**Written submission from
SRB Technologies (Canada) Inc.**

SRB Technologies (Canada) Inc.

Application for the renewal of the licence for
SRBT Facility

Commission Public Hearing

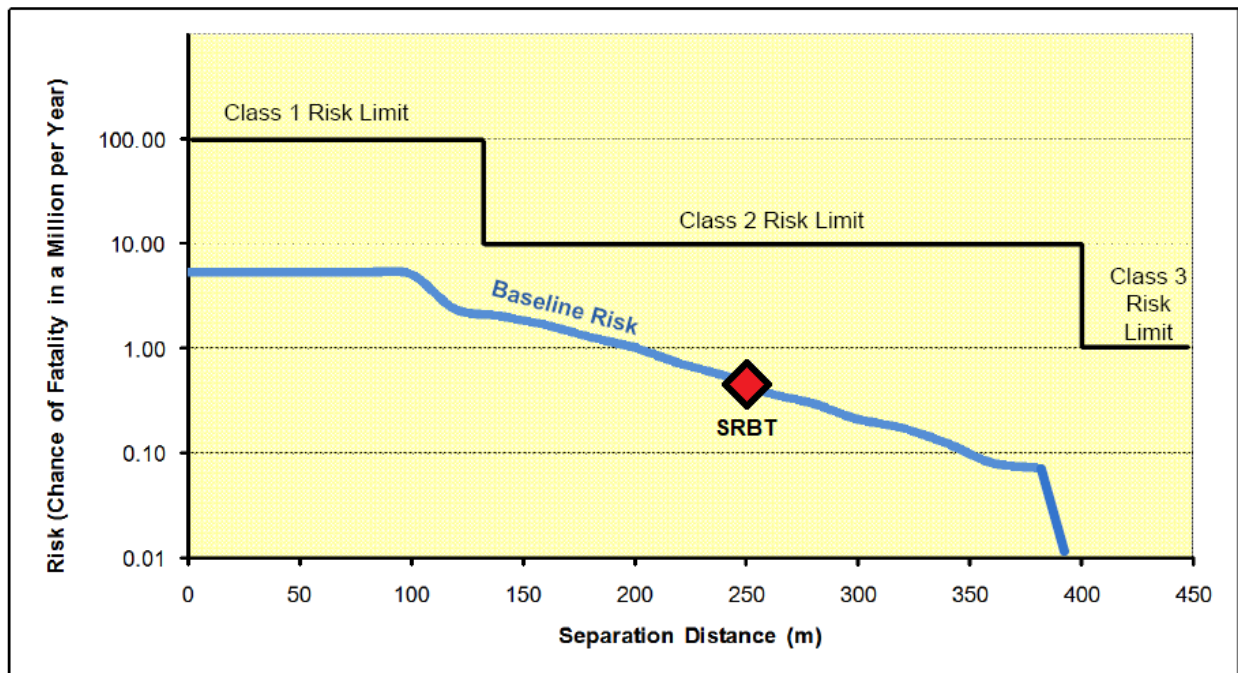
In section 3 of CMD 22-H8.14, the author provides several technical comments on the potential impact of an accident scenario at a propane transfer facility near SRBT.

The author of CMD 22-H8.14 also suggests that additional deterministic consequence analysis be integrated into the SRBT SAR in order to predict the consequences of a BLEVE on the facility. In the event such a low-probability event were to take place, the SRBT facility could indeed potentially be impacted by blast wave overpressure, thermal radiation from a fireball, and missile impact.

Combining the hazard frequencies, the probability of fatality, and the distances and characteristics of the land usage surrounding the transfer facility, a risk summary curve is generated that leads to the conclusion that the risk is below the MIACC Risk Assessment Criteria risk limits, and no additional mitigation is required on behalf of the facility operator.

The risk summary curve is presented here, including a highlighted point on the curve showing the distance at which the SRBT facility is located.

Nonetheless, the author's points are acknowledged and appreciated, in that the facility safety analysis could be improved to include more detail in these areas. SRBT will certainly take these points into consideration during the next review and revision cycle for the SRBT SAR, scheduled for November 2022.
